Village of Arlington Heights
Plat and Subdivision Committee
Community Room, 3rd Floor
Arlington Heights Village Hall
33 S. Arlington Heights Road
Arlington Heights, IL 60005
August 24, 2016
7:00 PM

To: Plat and Subdivision Committee
 Prepared By: Sam Hubbard, Development Planner
 Meeting Date: August 24, 2016
 Date Prepared: August 19, 2016
 Project Title: Karr Subdivision
 Address: 620 S. Beverly Ln.

STAFF DEVELOPMENT COMMITTEE REPORT

To: Plat and Subdivision Committee
Prepared By: Sam Hubbard, Development Planner
Meeting Date: August 24, 2016
Date Prepared: August 19, 2016
Project Title: 10 E. Algonquin Rd – Food Mall
Address: 10 E. Algonquin Rd.

SITE PLAN

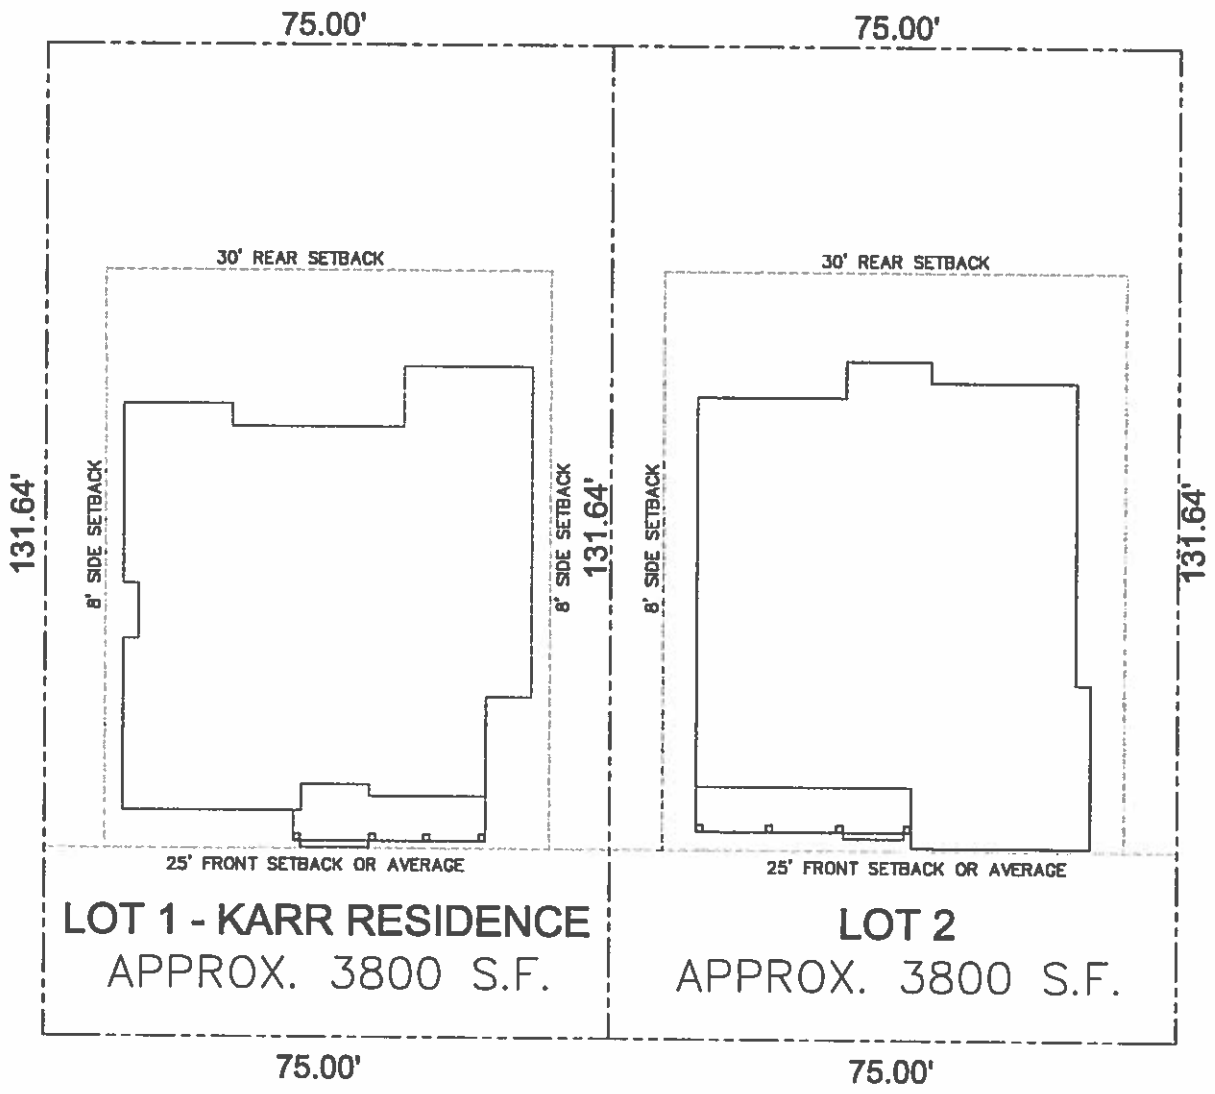
The proposed lots conform to side and rear yard setback requirements, however, the front yard setback is determined by the average front yard setback of the homes along the frontage (west side of Beverly Ln between Rockwell St. and Fairway St.). As part of the formal Plan Commission submittal, the petitioner must provide information regarding the average setback along the frontage to determine what the required front yard setback will be. It should be noted that the minimum front yard setback based on this average will be no less than 15' and no greater than 40'.

PRELIMINARY SITE PLAN

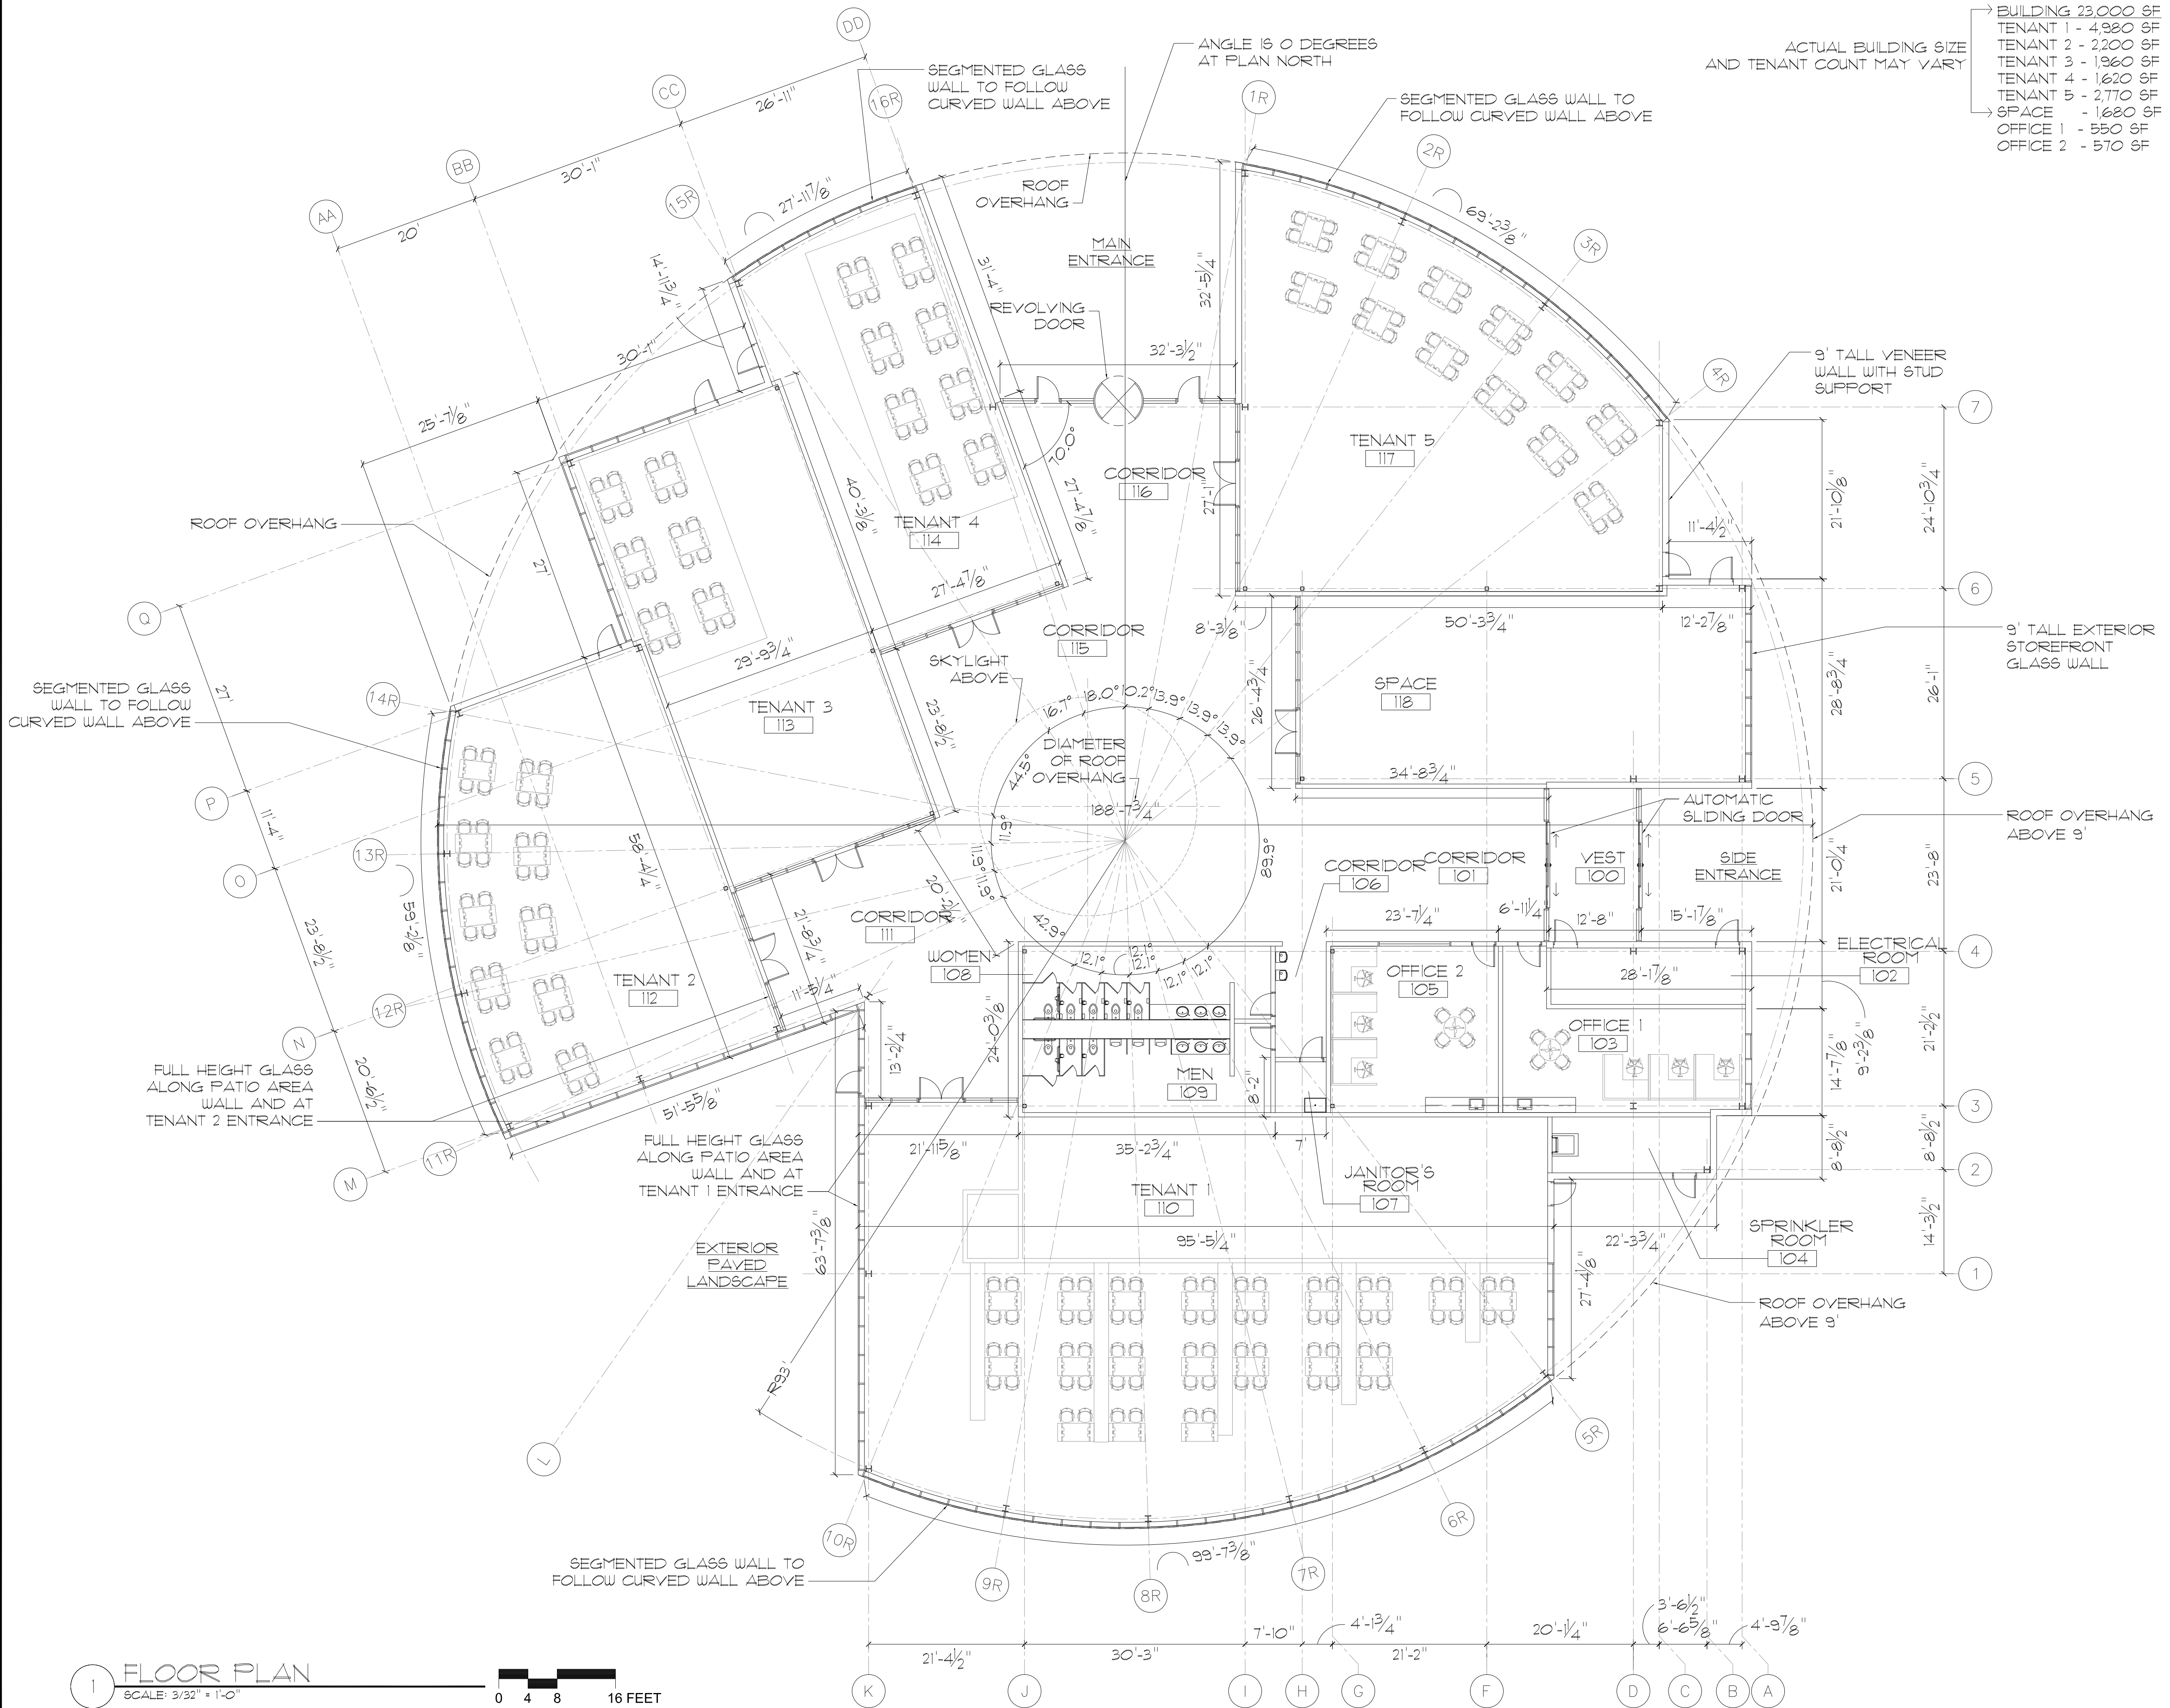
- **Sidewalks:** The existing sidewalk along Algonquin Road and Arlington Heights Road directly abuts the roadway with no parkway separation. Staff requests the applicant push the sidewalk back a minimum of 8’ in order to create a parkway due to the high speed and volume of traffic along both streets. Coordination with IDOT will be required. Any portion of the relocated sidewalk that overlaps onto the subject property will require an easement to the benefit of IDOT. Additionally, it should be noted that there are several mature trees along Arlington Heights Road, which the petitioner shall preserve.

- **Reciprocal Easement Agreements (REA's):** The existing site is encumbered by a REA which was established during the approval process for the Spring Hill Hotel. The proposed layout does not appear to conform to the access easements as outlined in the REA, and the petitioner will have to work with the owner of the existing Mitsuwa development to amend the REA.

- **Schematic Site Plan:** The Planning and Community Development Department has provided the petitioner with a conceptual site plan illustrating the desired layout for redevelopment of this area. The petitioner is requested to provide a site plan which conforms to this schematic site plan. Additionally, the petitioner shall provide reciprocal access to the benefit of the property to the north of the subject property, which will be effective upon the property to the north providing reciprocal access back to the subject property (which will be required once the northern property is redeveloped). Finally, the conceptual site plan shows a jogged access aisle (labeled “Future Access Easement”) where this aisle connects to an existing drive aisle. This jogged orientation should be straightened and the construction of the drive aisle may be required during the redevelopment of this site.

- **Landscaping:** The applicant will be required to provide a tree preservation plan and landscape plan as part of the formal Plan Commission application. The proposed concept plan does not appear to provide the required landscape islands at the end of every 20 parking stalls.

- **Dumpster Enclosure:** The proposed location of the dumpster enclosure is not suitable. The petitioner is requested to find an alternative location towards the rear of the building to keep the enclosure shielded from Algonquin Road and Arlington Heights Road to the maximum extent possible.

It should be noted that a traffic study must be submitted in conjunction with the proposed application. Furthermore, the applicant has proposed modifications to the Arlington Heights access drive, which will require review and approval from IDOT.
